Harborview Mixed-Use

SYSTEMS REVIEWED

Specified Inspection Platforms — Field Observation Report #4

Meeting Minutes

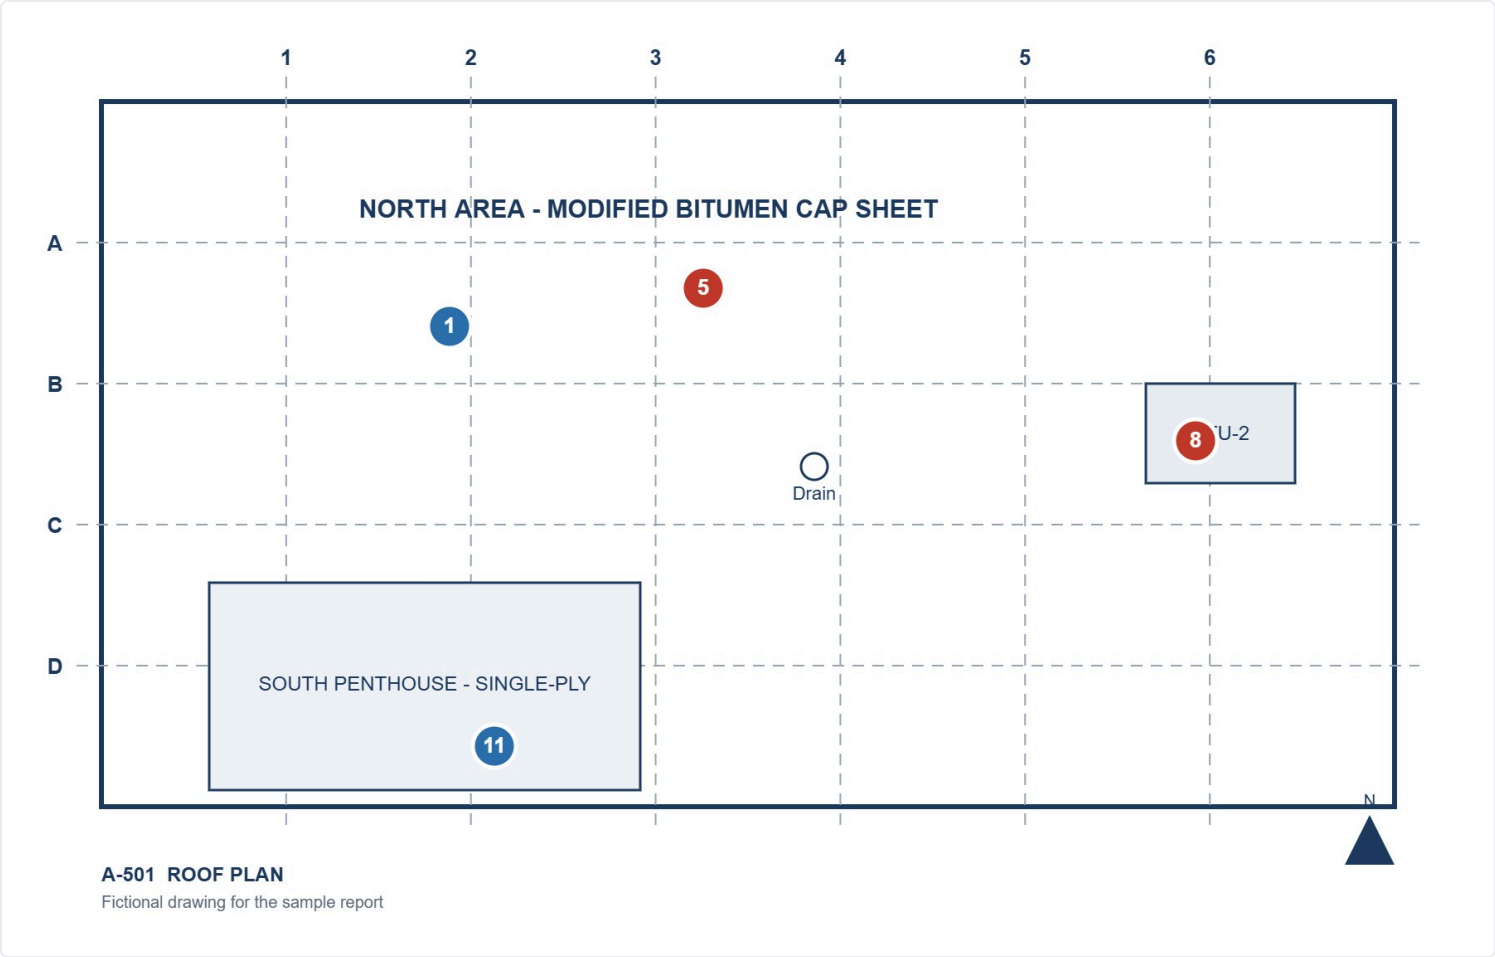
Sheet metal follows the cap sheet by one day; coping after the flood test.

Item 1.3

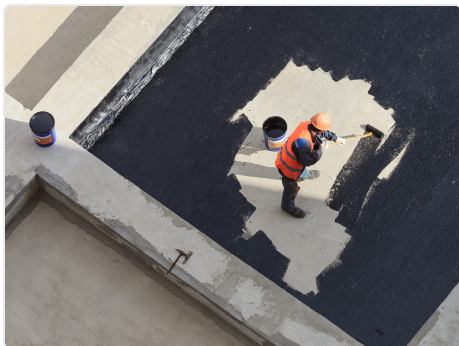
Liquid flashing at the RTU curb was applied to the deck only; the curb face and the top termination are not yet flashed.

Contractor to complete the curb flashing and terminate under the counterflashing.

Photograph: 3

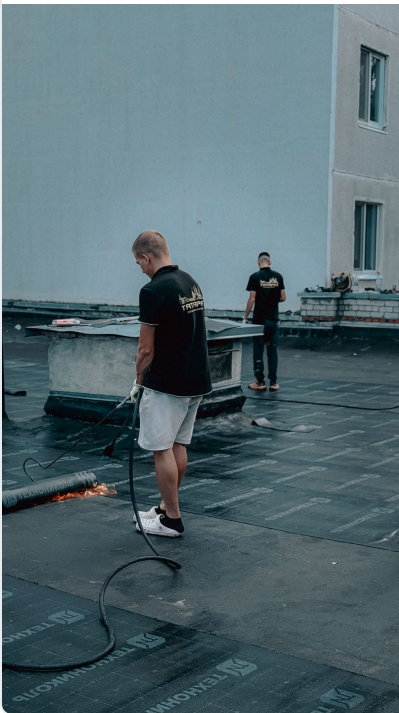
Roll end trimmed square; selvage edge clean for the next side lap.

Photograph: 7

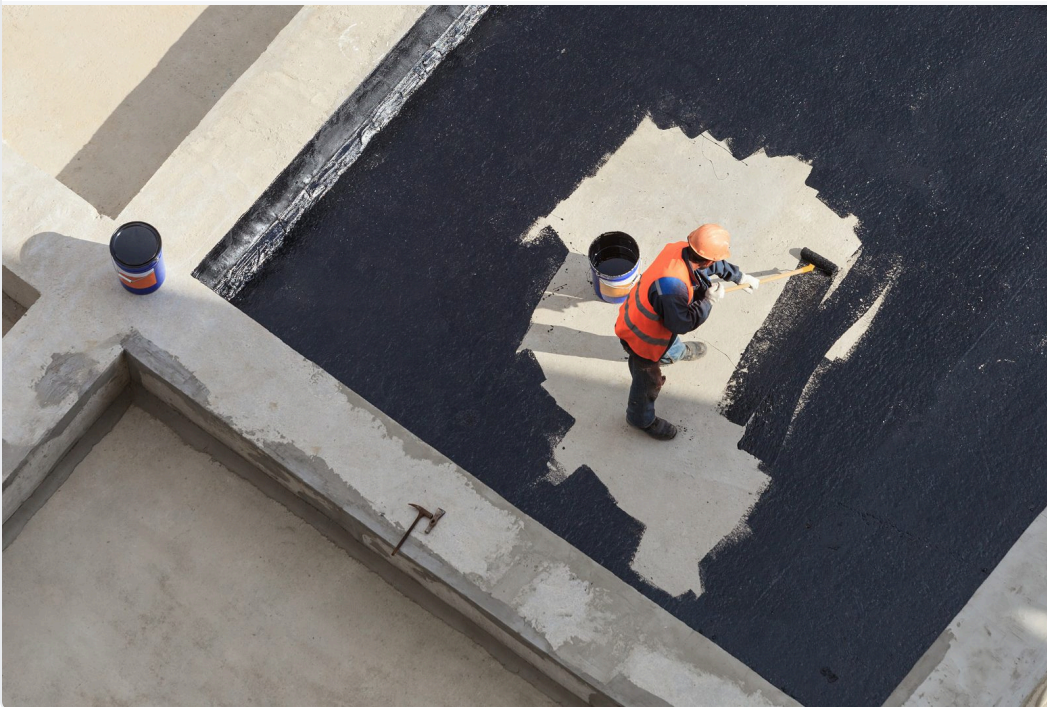
End lap torched and rolled; bleed-out visible at the edge.

Photograph: 9

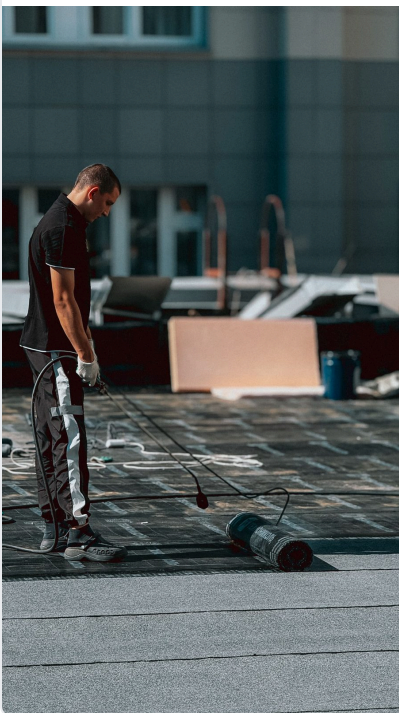
Torch held to the roll with a continuous melt line ahead of it.
